Addendum #04

General Contractor Services

For The Lathrop House Relocation Project

Question #5 – On sheet A-2.01 please address this potential issue. See below:

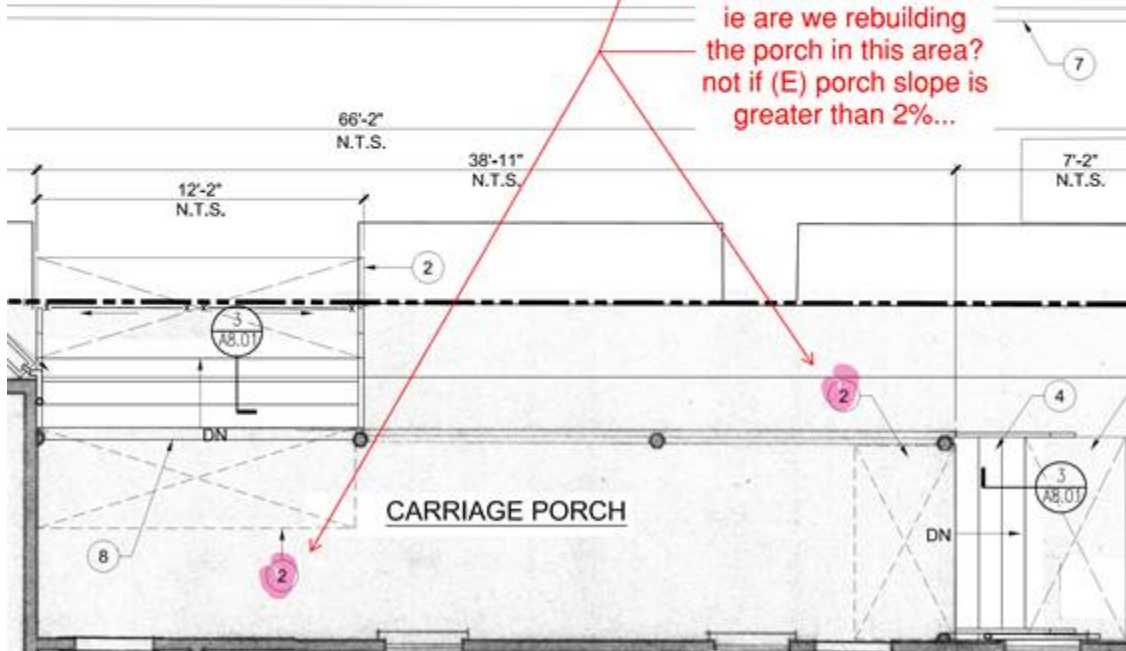
What does this mean?
ie are we rebuilding
the porch in this area?
not if (E) porch slope is
greater than 2%...

The existing porch deck complies with the level landings required at the top of stairs. Keynote 2 just clearly defines the location of the level landing which needs to remain compliant after the building relocation.

Question #6 –On sheet A-3.01 please address this potential issue.

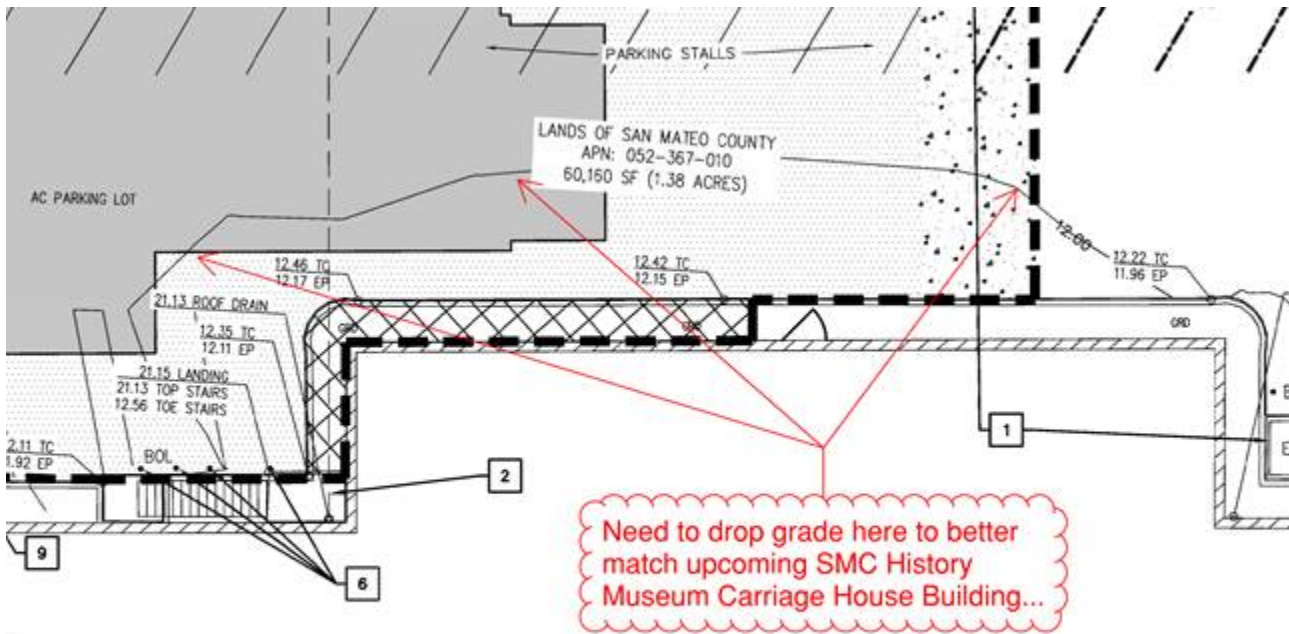
What is plan "B" when the panels are NOT salvageable?

As noted in the Pre-Bid walk, it is anticipated that a small percentage of the stamped sheet metal panels may be damaged during removal. There were no conditions surveyed that appear to create a situation where salvage of the panels would be difficult. So with careful handling, there should be an adequate quantity of the sheet metal panels salvaged that can be reinstalled.

The primary goal is to put the panels back in the same location on the building as where they were removed. Also noted in the field, there is a difference in grade change from front to back at receiver site that will require some of the existing lower panels be trimmed before re-installation. The trimmed pieces will also provide some quantity of panels that can be utilized to patch /repair damaged panels.

Conditions may be reviewed with PDU and Architect during construction for appropriate repair.
